From: [REDACTED]
Sent: Sunday 29 March 2026 23:07
To: FPladmin
Subject: Resident Submission – Cherrywood Town Centre Development
Categories: Jen

From: [REDACTED]
Sent: Tuesday 21 April 2026 18:10
To: FPladmin
Subject: Submission on Material Alterations to Amendment No. 11 – Cherrywood Planning Scheme

Re: Proposed Amendment No. 11 Material Alterations/Modifications, Cherrywood SDZ

RE: Town Centre and Environs Amendment, Cherrywood SDZ Proposed Amendment No. 11 to the Cherrywood Planning Scheme, An Coimisiún Pleanála ref: ZF06D.321573

2.3 Land Use – Indicative

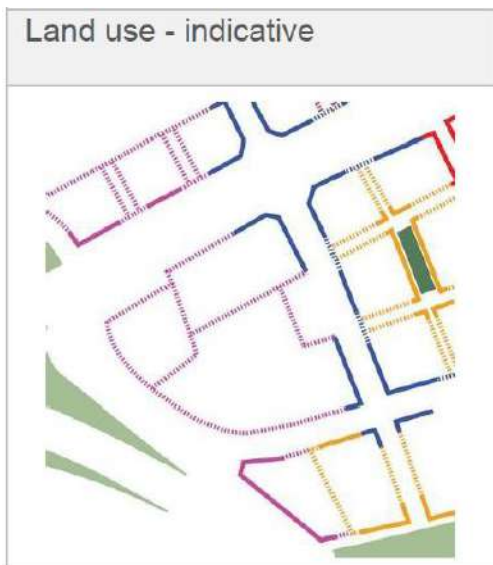
It is requested that the Land Use diagram be amended to provide a Flexible Mixed-Use Frontage at Cherrywood Avenue West.

2.4 Street Wall Continuity of Frontage

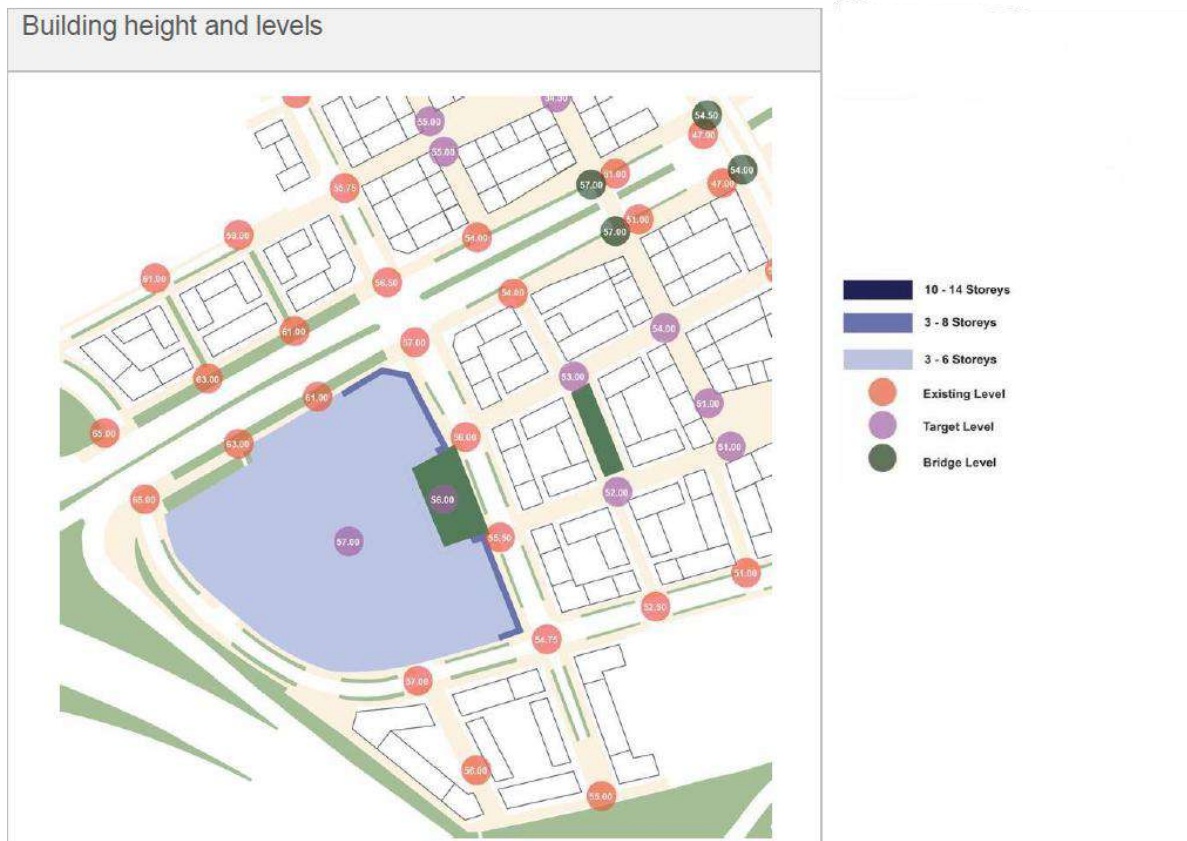
It is requested that the Street Wall diagram be amended to provide 80-100% Street Wall Continuity at the north and south ends of Cherrywood Avenue West.

3.1 Plot Ratio

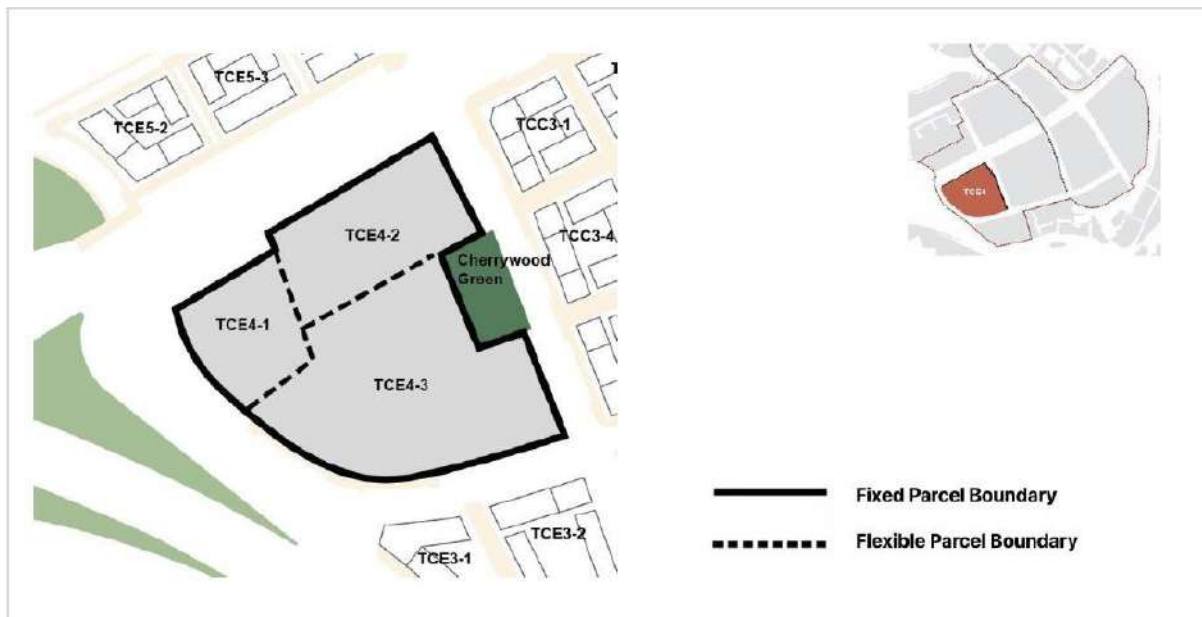
As set out in the initial submission, it would not be possible to achieve a plot ratio of 1.5 due to the relatively low floorspace (c. 25,000sqm) of the Arena building, which will occupy a significant area of the Superblock. The Chief Executive's Report recommended the Addendum *as a solution to address this extraordinary future potential development that said be managed by way of a proposed Addendum to the Planning Scheme.*

The table contained within the Addendum contains the same ‘Plot Ratio range’ of 1.5 to 2.0 as per the original Amendment 11. This equates to a floorspace requirement of 50,850sqm to 67,800sqm.

Figure 2: Requested Minor Alteration to Proposed Modification – highlighted in red outline. (Source: DLR February 2026, Annotated by TPA.)

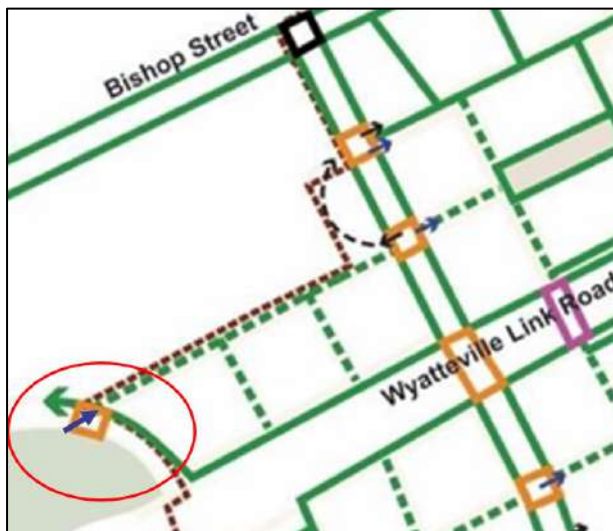
The purpose of this Submission is to seek a minor amendment under Proposed Material Alteration/Modification No. 19 (as it pertains to Appendix B - Urban Development Code for the TCE5 lands). See Figure 1 below, which shows the ‘Proposed Modification’ version of the Movement Diagram for TCE5 (see Page 44 of the Urban Design Code: Controls and Guidelines, February 2026).

The amendment sought to that diagram is shown on Figure 2 below and comprises an additional arrow clarifying the potential servicing access point to TCE5.

There are limited options for vehicular access to TCE5, having regard to its relationship to the WLR and limited frontage to other roads, therefore it is particularly important in this instance to ensure clarity for service access.

The minor alteration sought is that the Movement diagram would include an additional arrow as shown above, namely:
